VALUE ENGINEERING WORKSHOP

WIDENING I-20 TO SIX LANES Richmond/Columbia County, GA

05 November 2004

PROPOSAL NUMBER:	RW-1.0
-------------------------	--------

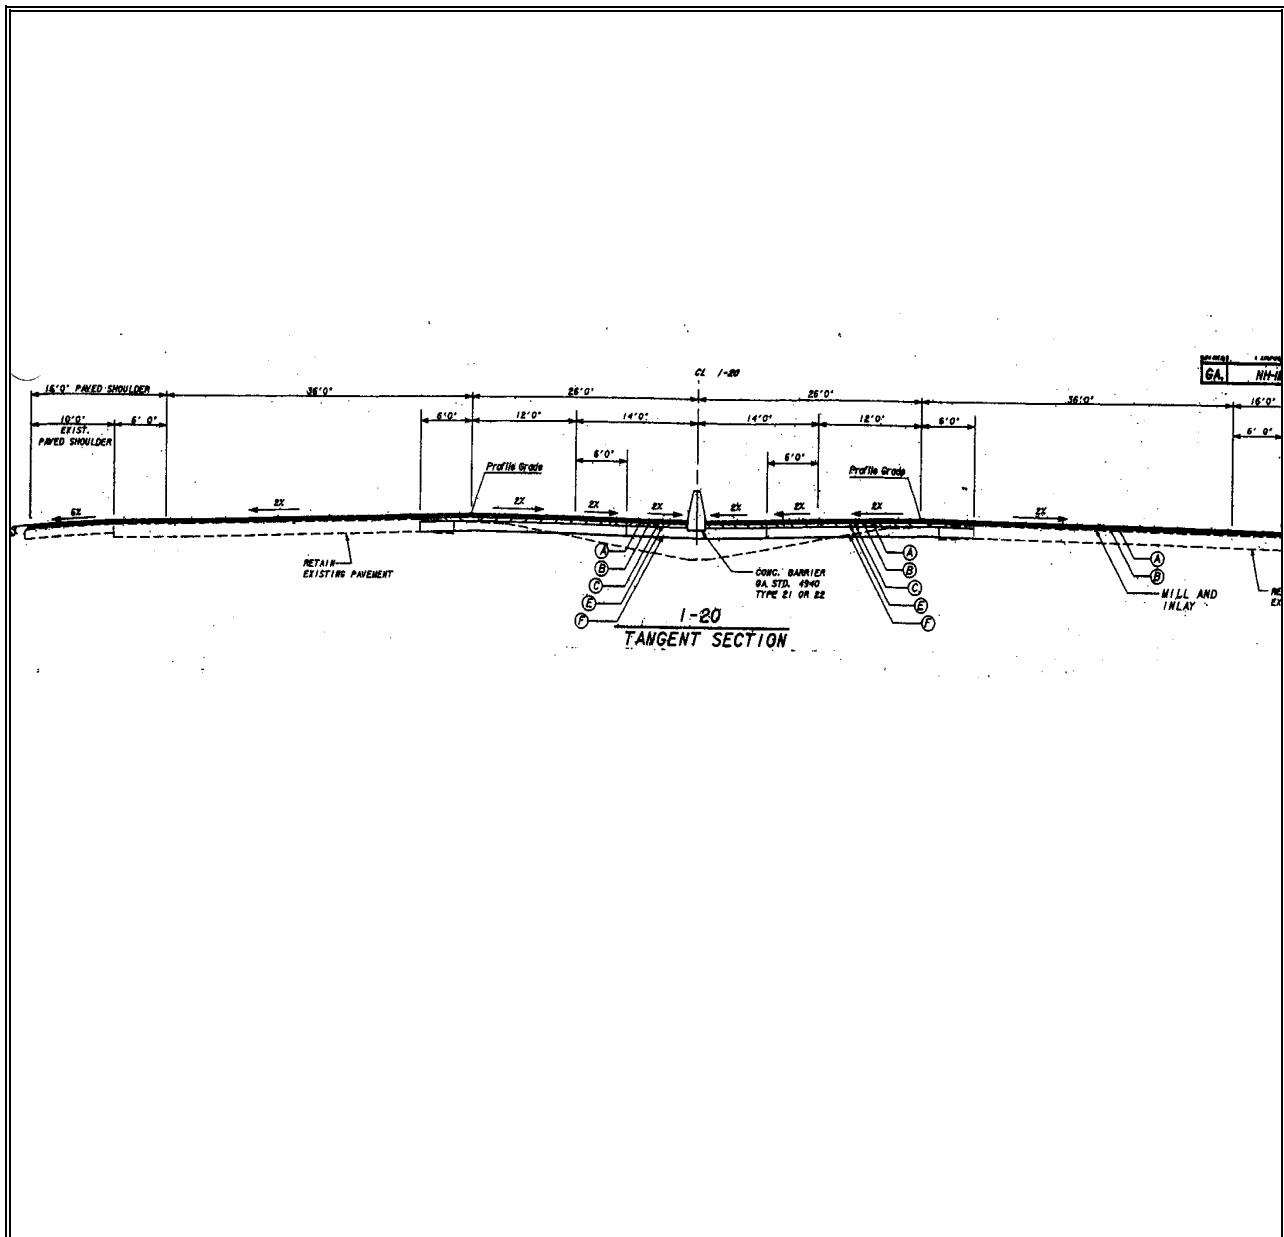
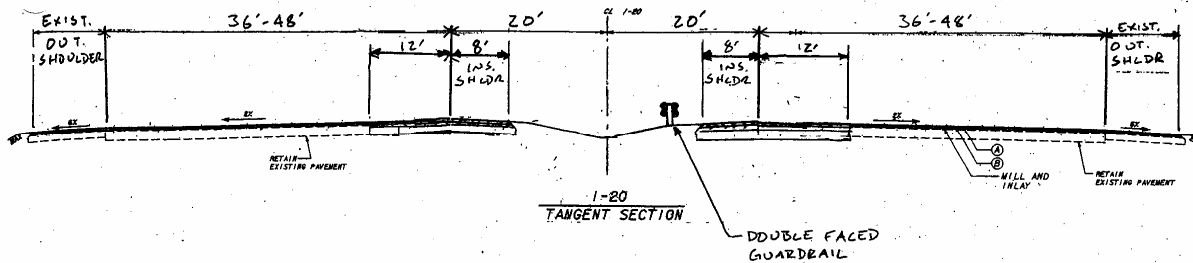
PROPOSAL DESCRIPTION: MINIMIZE PROPOSED PAVEMENT WIDENING TO PROVIDE MINIMUM SHOULDERS AND ELIMINATE PAVEMENT FOR FUTURE LANES AND MEDIAN BARRIERS.

ORIGINAL DESIGN: The original design consists of paving the entire existing 64' median and providing a concrete median barrier. With a six foot shift in the travel lane towards the median the proposed section would include a 14' paved inside shoulder and a 16' paved outside shoulder.

PROPOSED CHANGE: The proposed change recommendation would eliminate additional paving that is not required for the minimum interstate laneage and shoulders. This change would require a grassed median with double faced guardrail along the entire length of the improvements.

The proposed traffic volumes do not currently justify the future construction of the fourth through lane. Upon widening to four through lanes the outside shoulders will then become inadequate and will require reconstruction.

PROPOSAL NUMBER:	RW-6.0
-------------------------	--------

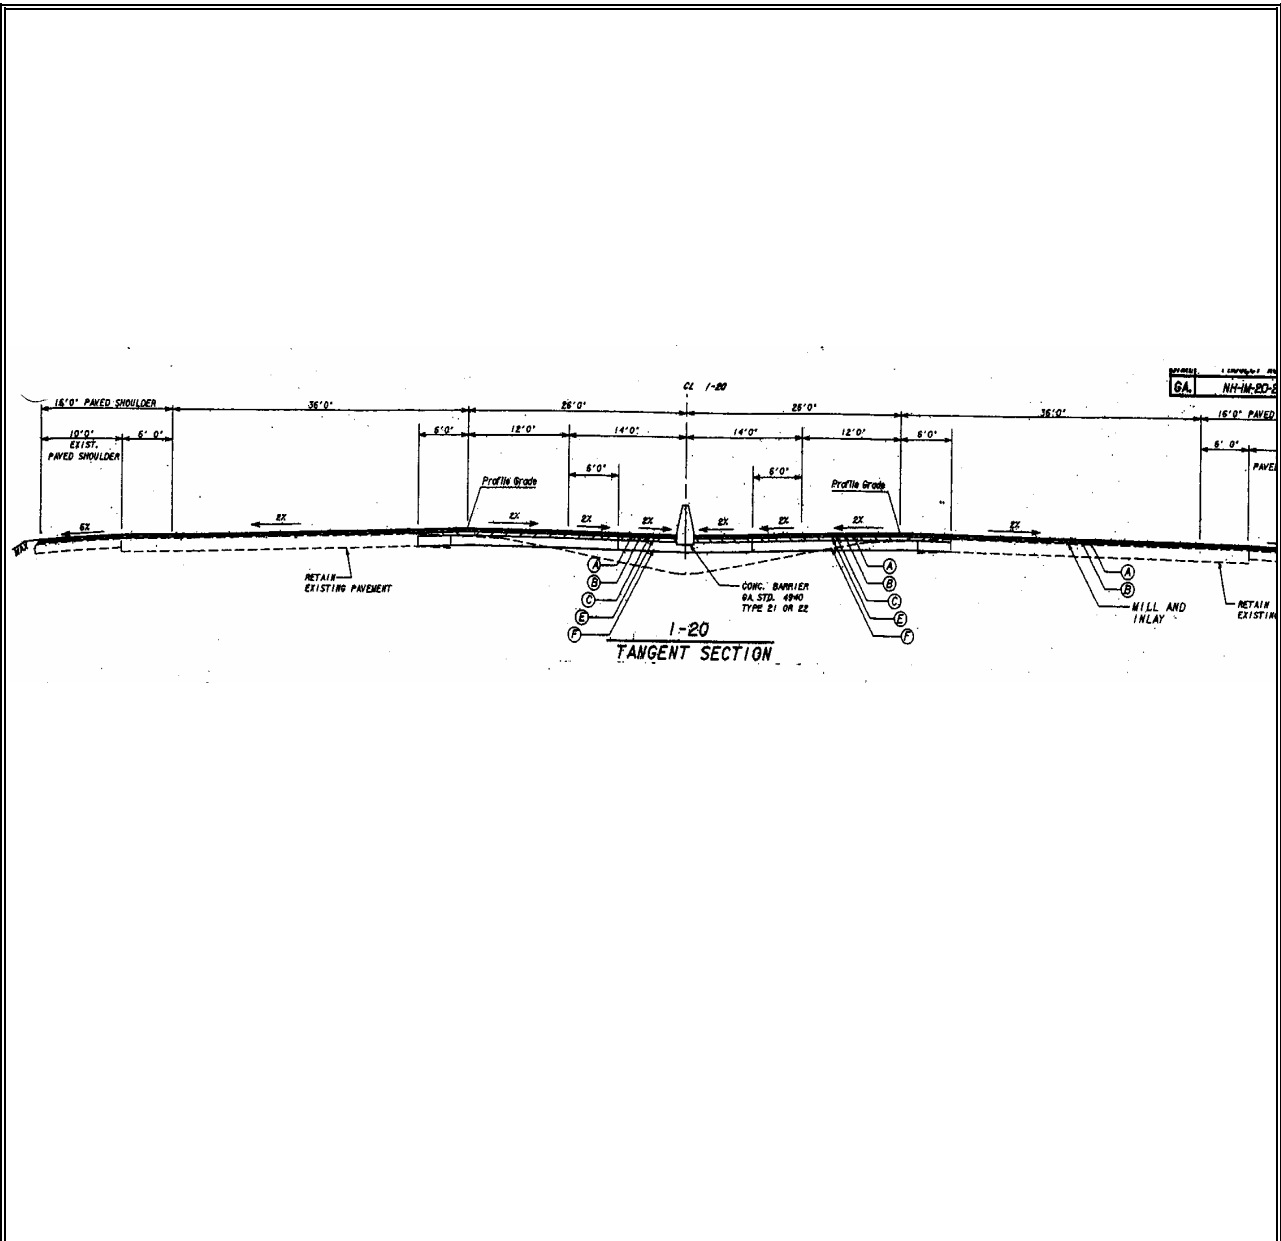
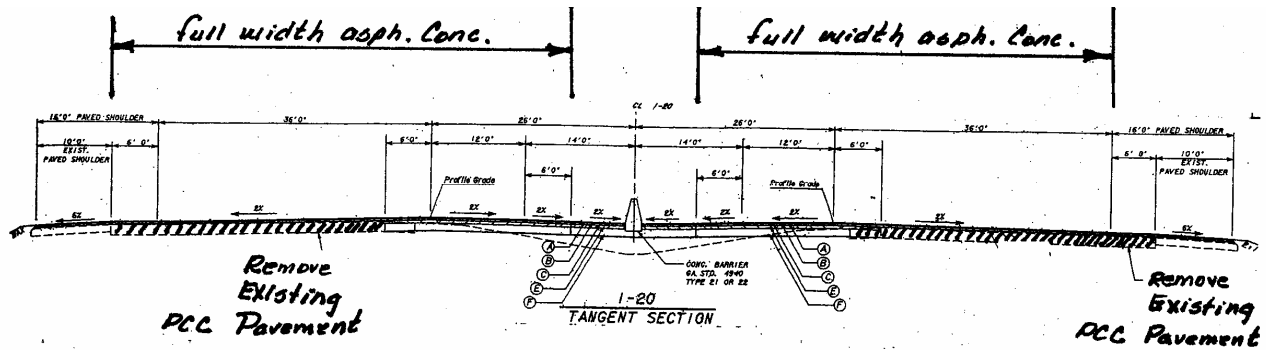
PROPOSAL DESCRIPTION: REMOVE ENTIRE EXISTING ROAD EASTERN PORTION OF THE PROJECT AND REPAVE TO TYPICAL DESIGN SECTION WITH FULL DEPTH ASPHALTIC CONCRETE PAVEMENT.

ORIGINAL DESIGN: The original design stipulates leaving the outside PCC pavement lane in place and widening 36 feet inside with 12 inches of PCC pavement.

PROPOSED CHANGE: The proposed recommendation is to delete/demolish the PCC pavement and provide the same asphaltic concrete pavement structure (section) as proposed for the Western portion utilizing the same typical dimensions as shown. The recommendation also calls for the removal of the outside PCC pavement lanes and replacing with full depth asphaltic concrete paving.

A major problem with the current design is that a substandard cross slope (1%) on the outside lanes controls the design template. The substandard cross slope is extended with the current design with an anticipation of increased wet weather accidents. For about 1% increase in project reconstruction cost the substandard cross slope can be corrected to current FHWA design standards; thereby greatly reducing GDOT owner liability

RW-7.0

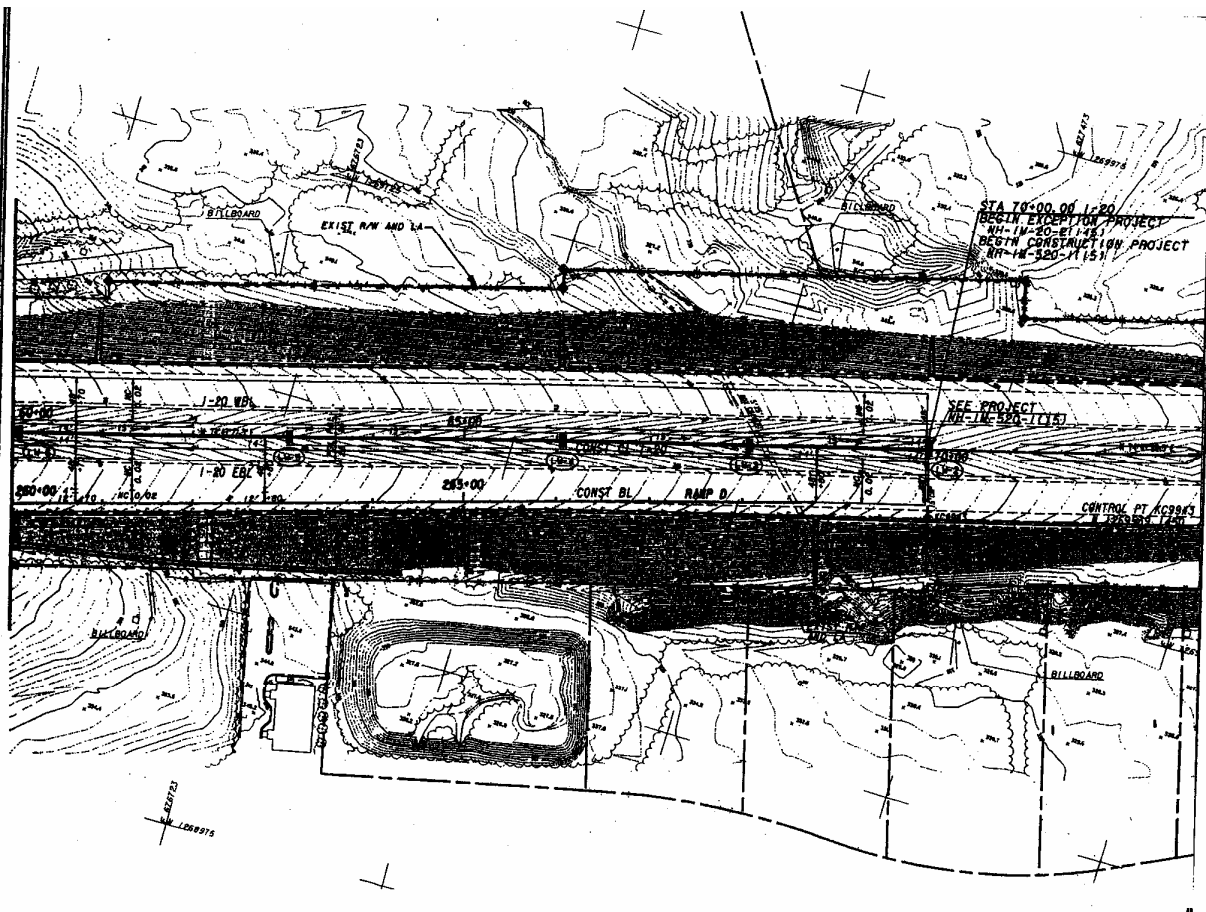
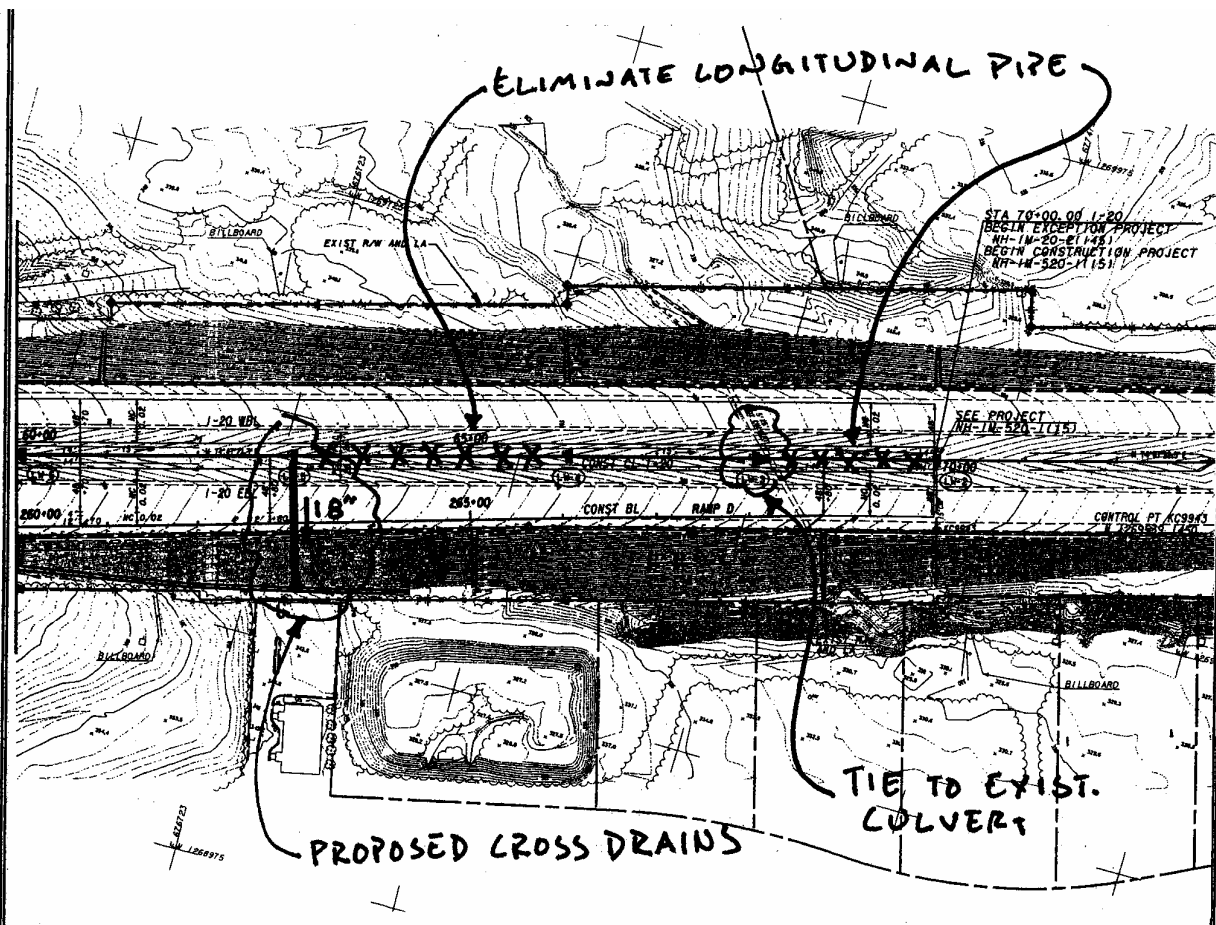
PROPOSAL DESCRIPTION: MODIFY DRAINAGE LAYOUT TO PROVIDE ADDITIONAL CROSS DRAINS OR RESIZE EXISTING CROSS DRAINS.

PROPOSED CHANGE: The proposed changes recommendation would include the construction of additional median cross drain pipes to accommodate the increased runoff within the median. These changes would allow for a decrease in the current design longitudinal pipes.

The existing cross drains conditions are unknown. Due to the age/conditions of the pipes it would be a benefit to replace the pipes during this project construction.

The construction of the additional cross drains would reduce the total length of storm drain pipe as well as provide a safer design.

SB-1.0

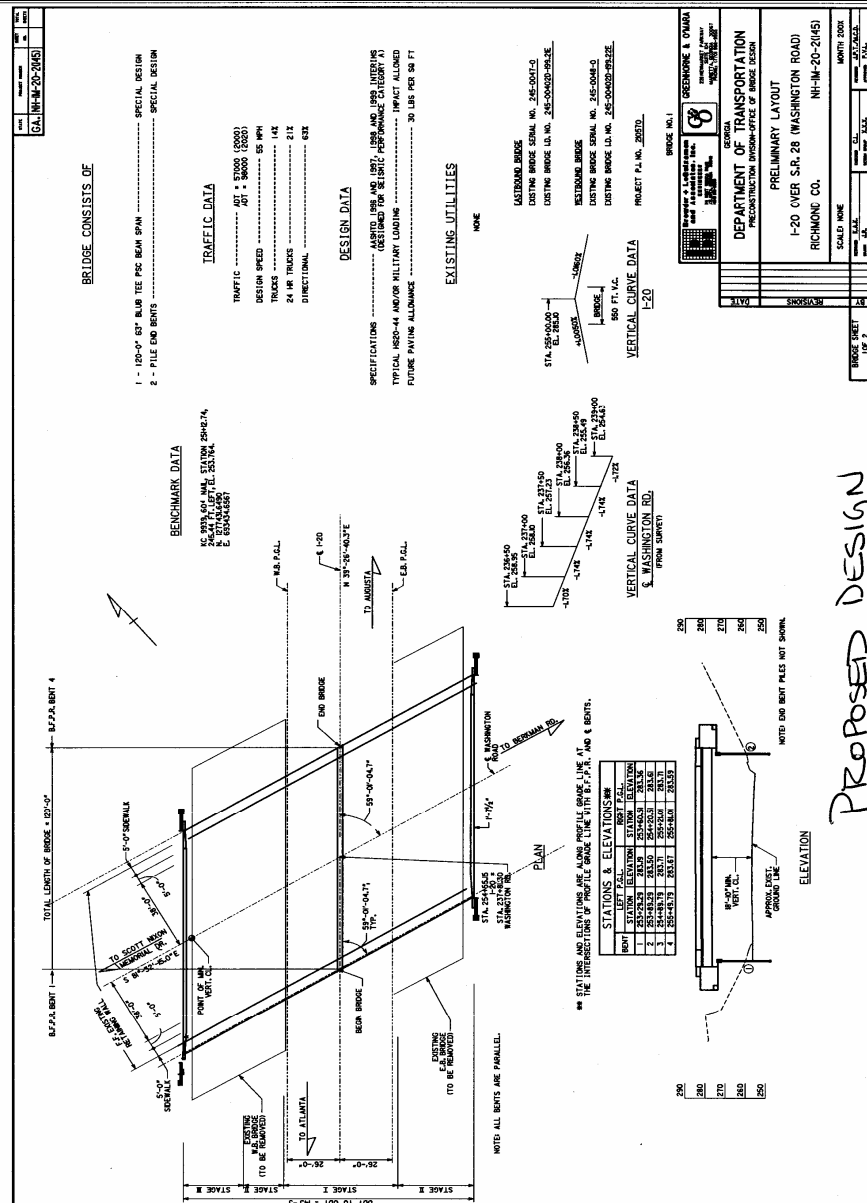
PROPOSED CHANGE: The proposed change recommended design suggests the use of a single span bridge with MSE walls to accommodate a straight alignment of sidewalks behind the pier of the existing piers.

SB-4.0

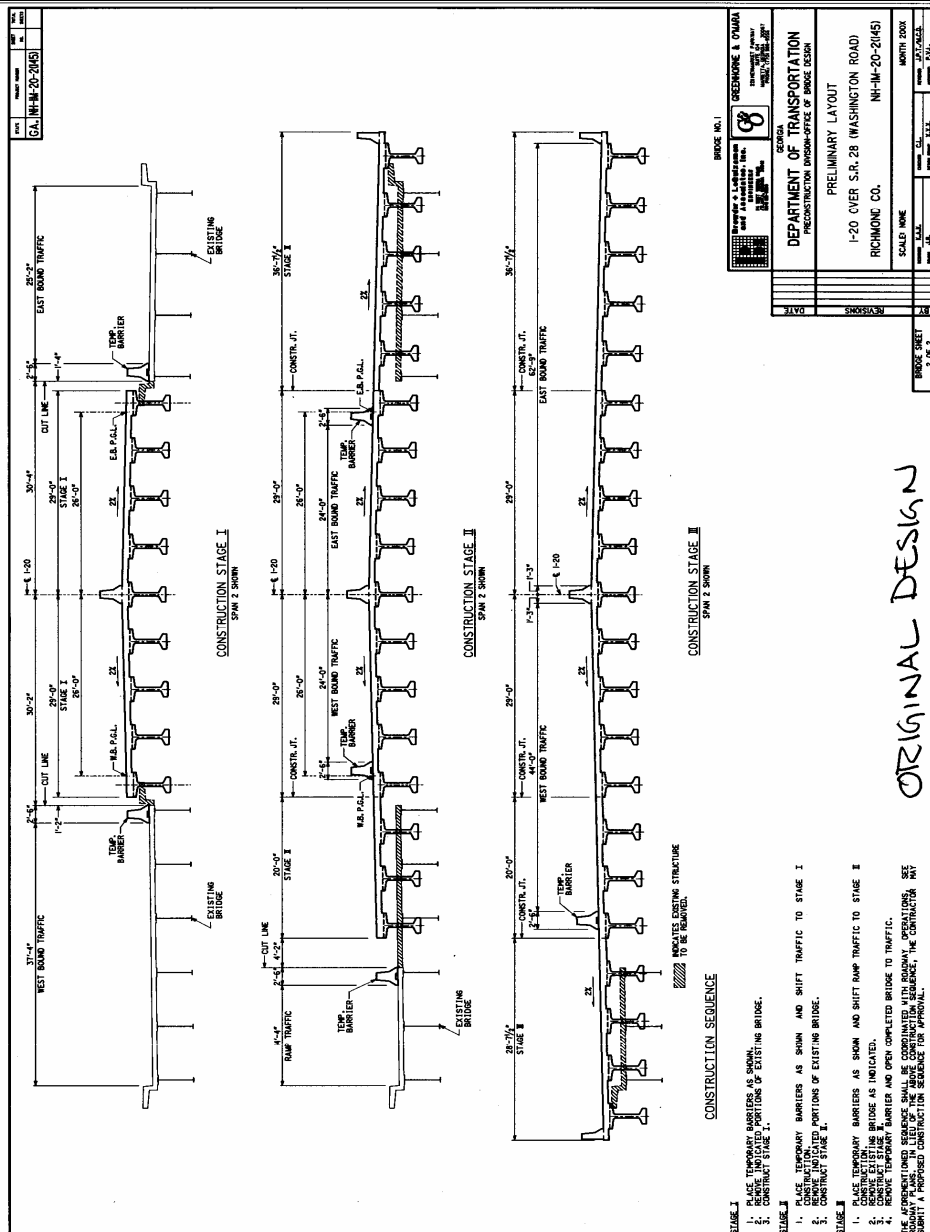
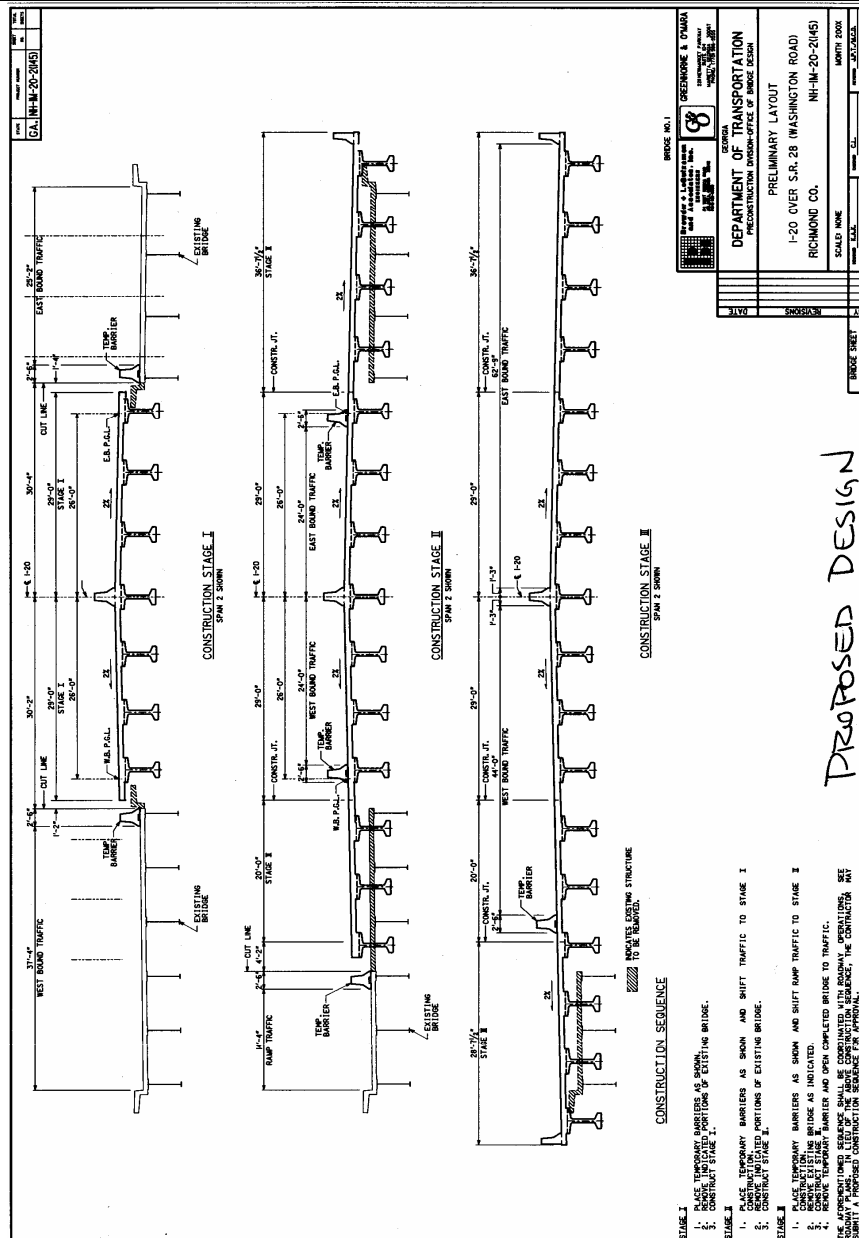
PROPOSED CHANGE: The proposed recommendation suggests the use of HPC beams, which reduces the number of beams from 21 to 17 per span drastically reducing the costs and construction time.

SB-5.0

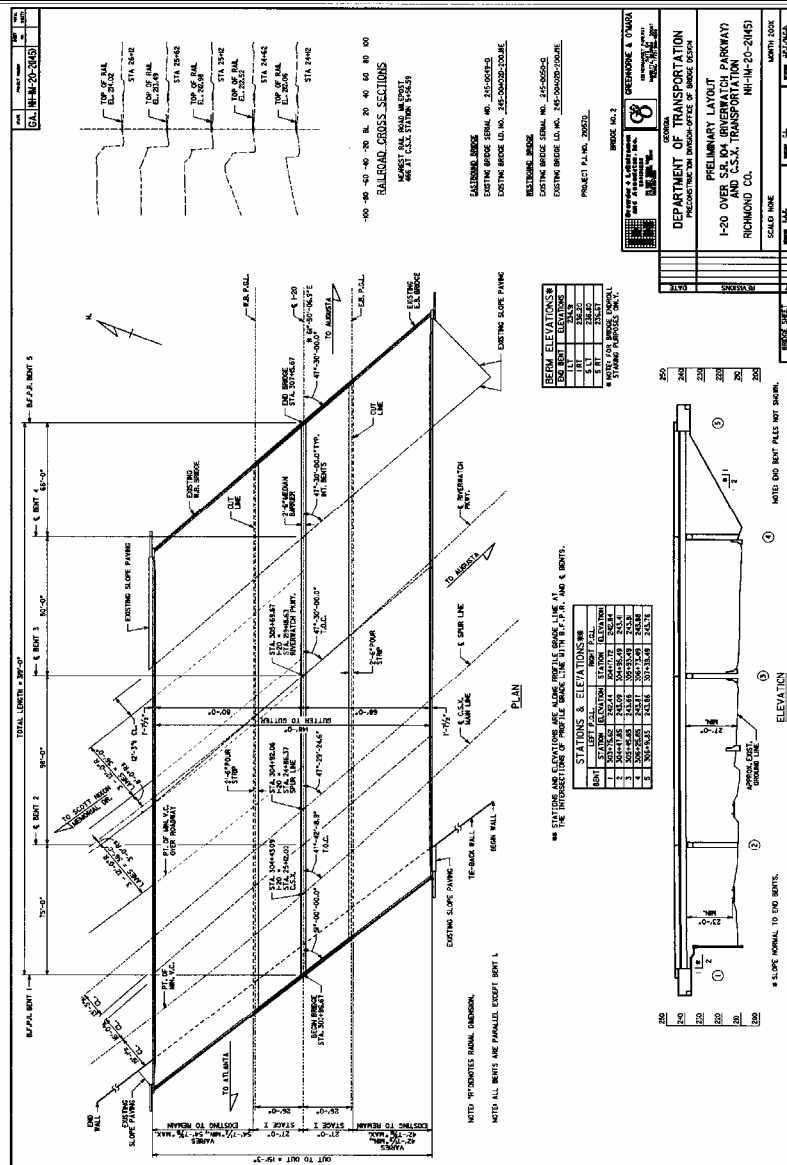
PROPOSAL DESCRIPTION: REPLACE RIVER WATCH BRIDGE WITH PSC
BEAMS MSE END BENTS.

PROPOSED CHANGE: The recommended design suggests the complete replacement of the existing bridges by constructing a completely new 143'-3" wide by 259' long bridge.
